Re: Planning and Development Act 2000-2021 and the statutory regulations (as amended). Application by Xilinx Ireland for retention of permission for development at this site at Bianconi Avenue, City West Business Campus, Saggart, Co. Dublin. The development consists of the retention of the generator compound (391sqm) consisting of three generators along with three transformers and ancillary 3 no. diesel tanks and perimeter treatment on a permanent basis on the southern perimeter of the site with Orchard Avenue. The development also consists of the retention of 3 no. signs (10.94sqm) as follows: Retention of 1 no. sign (0.57sqm) on plinth at the corner of Bianconi Avenue and the N82; Retention of 1 no. sign (4.58sqm) on eastern elevation facing the N82; and Retention of 1 no. sign (5.79sqm) on northern elevation facing Bianconi Avenue. The development will include retention of all revisions to the permitted landscaping and site development works required.

Reg. Ref. SD22A/0109

ADDITIONAL INFORMATION

Excerpt from Drawing no. G1359-12 Rev. D submitted to Irish Water as part of diversion application

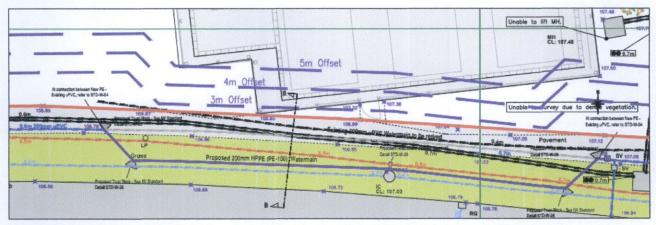
1. a) The gas compound appears to be 1 metre from a 200mm uPVC public watermain located under the footpath to the south of the site. Irish Water Standard Details for water Infrastructure require 3m clear distance from a main of this size. Therefore the applicant is requested to obtain and submit the written agreement of Irish Water to the proposed development.

Following discussions with Irish Water it was agreed that a Diversion application needed to be made to them on the 10th November 2022 by Gordon White of Gordon White Consulting Engineers Ltd. This application for the diversion included details of the generator compound in question, the position of the existing 200mm watermain that runs along the footpath, and the nature and extent of the proposed diversion of the watermain, which was proposed to be c. 3m. An excerpt of this is shown below and was agreeable to Irish Water.

"Irish Water has reviewed your enquiry regarding Planning Retention and proposed diversion of Irish Water's 200mm uPVC watermain at Xilinx Ireland, 2020 Bianconi Avenue, Citywest Campus, Dublin 24, D24T683, as indicated on drawing number G1359-12 Rev D. Based upon the details you have provided with your enquiry and as assessed by Irish Water, we wish to advise you that, subject to detailed design being agreed and valid agreements being put in place, the proposal can be facilitated."

We can therefore confirm that the applicant has sought and obtained the written agreement of Irish Water to the proposed development as now proposed.
